REFUELING OPERATIONS

SPENT FUEL CASK HANDLING CRANE

3.9.13 Crane travel of the spent fuel shipping cask crane shall be restricted to prohibit a spent fuel shipping cask from travel over any area within one shipping cask length of any fuel assembly.*

FIGURE 1
 AREA OF SPENT FUEL POOL IMPACTED BY CASK

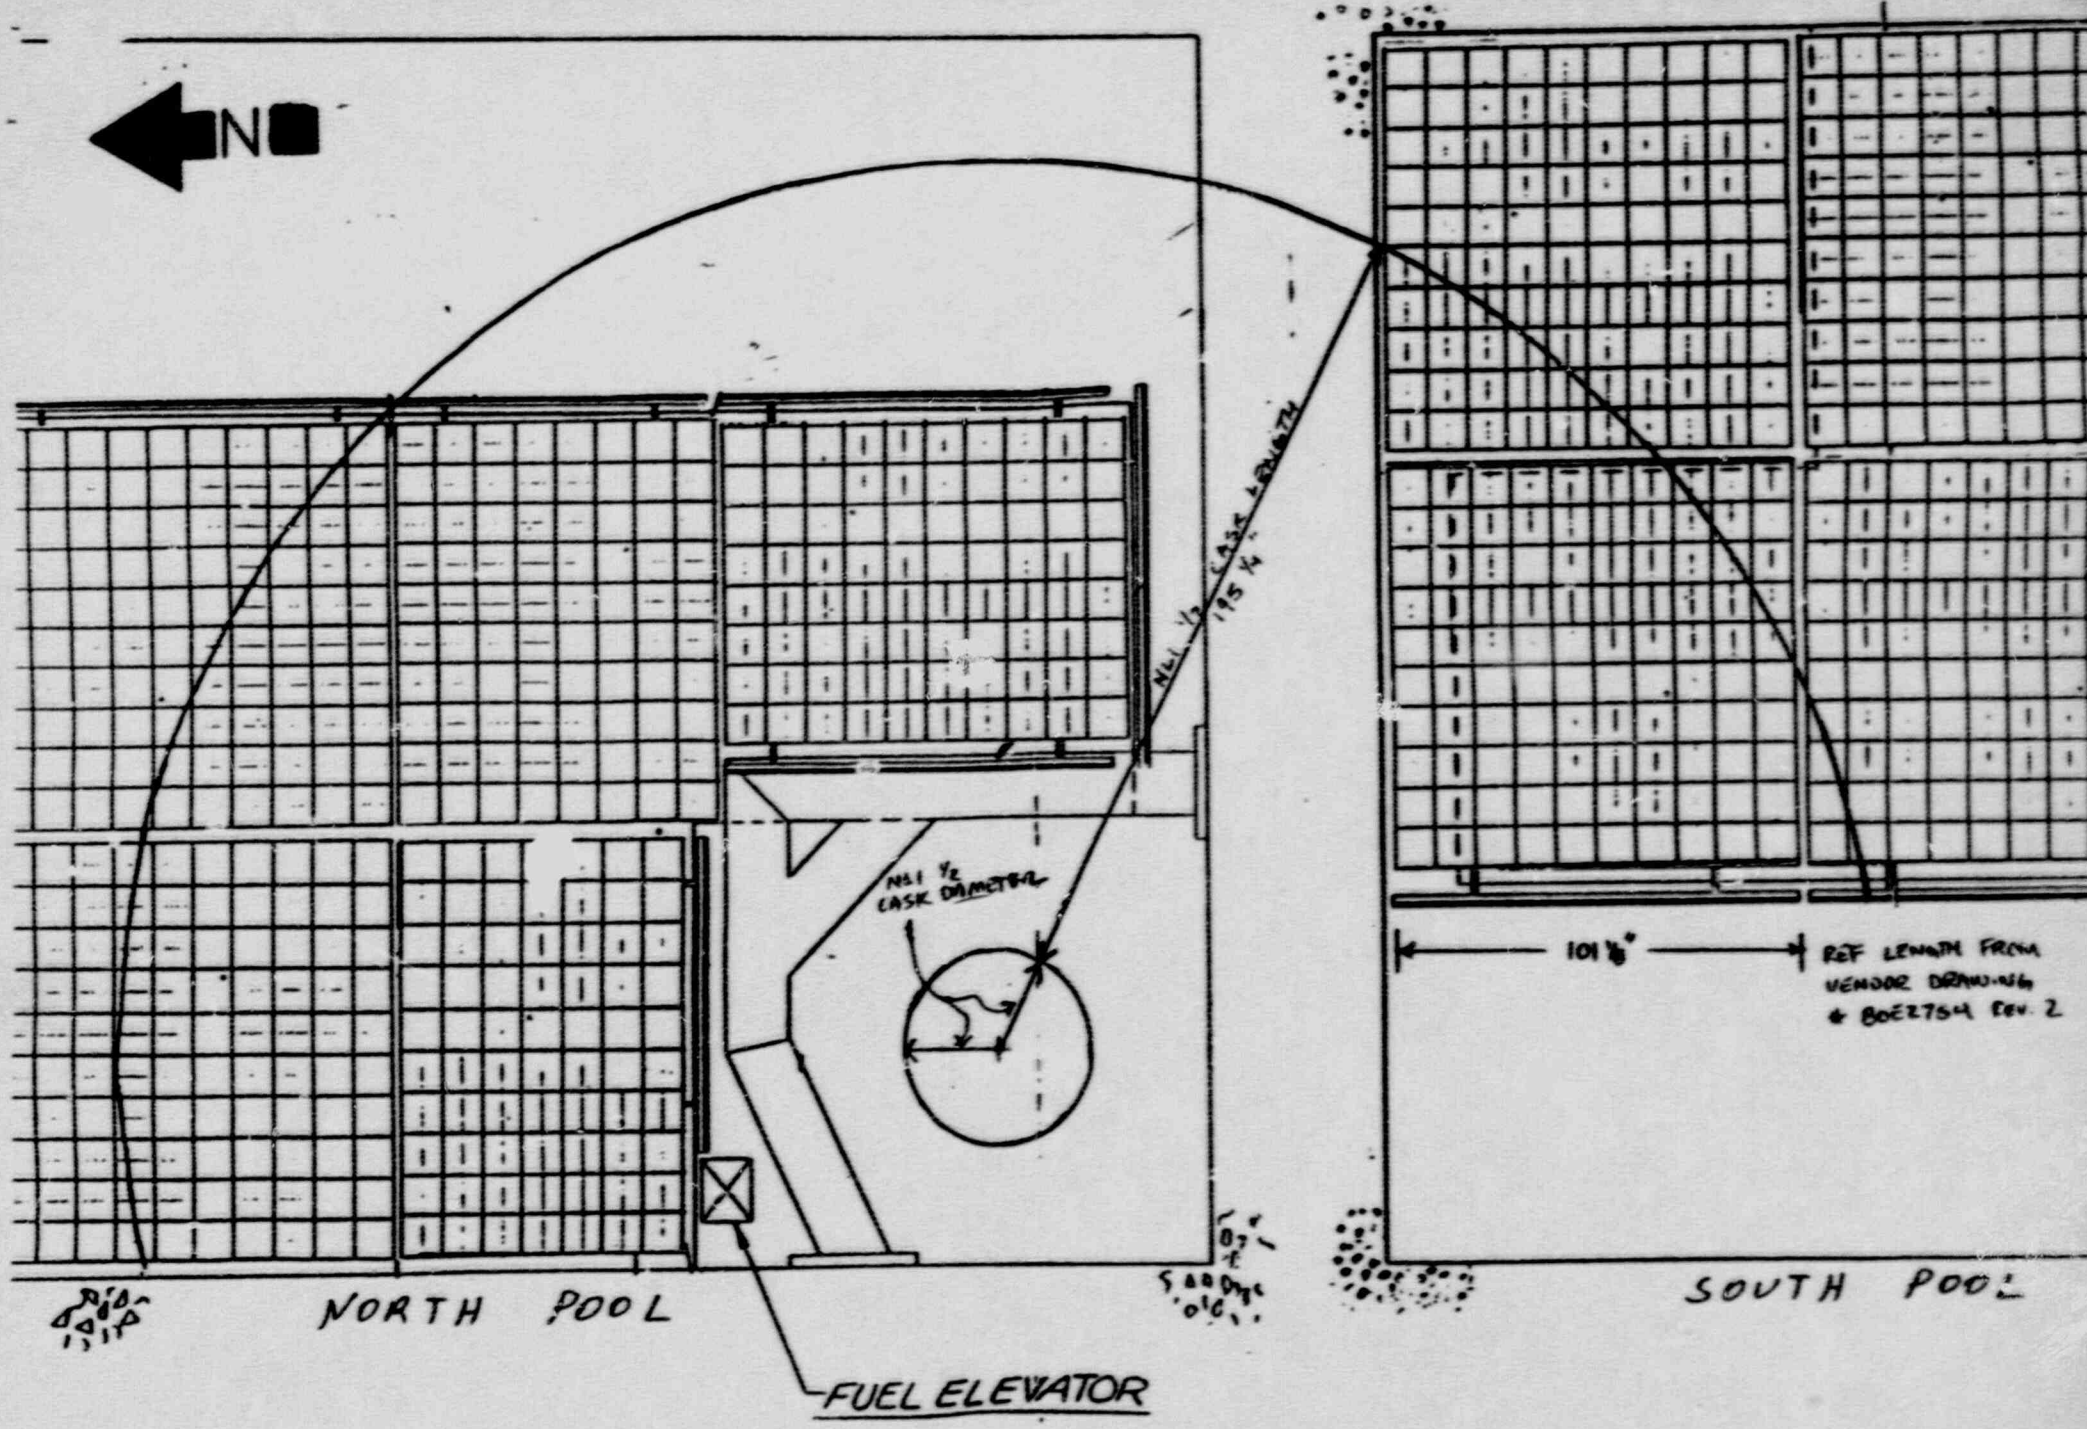
These conditions are modified to permit shipping cask travel to and from the cask pit in the presence of fuel within one cask length radius of the pathway provided the boric acid concentration in the spent fuel pool is greater than or equal to 1000 ppm AND the following criteria are met by all assemblies within one cask length radius of the pathway: 1) initial enrichment less than or equal to 4.1 w/o U-235, 2) Burnup greater than or equal to 28,000 MWD/MTU, and 3) greater than 440 days elapsed from the shutdown of the last operating cycle in which the assembly was present in the core. Crane interlocks and physical stops which restrict a spent fuel shipping cask from passing over any area within one shipping cask length of any fuel assembly not satisfying the above criteria shall be demonstrated OPERABLE within 24 hours prior to using the crane for moving a cask within one length of fuel assemblies meeting the above criteria. These modifications are applicable only to the shipment of fuel rods supporting the EPRI sponsored hot-cell work and for the shipment of a reactor vessel weld material surveillance capsule.
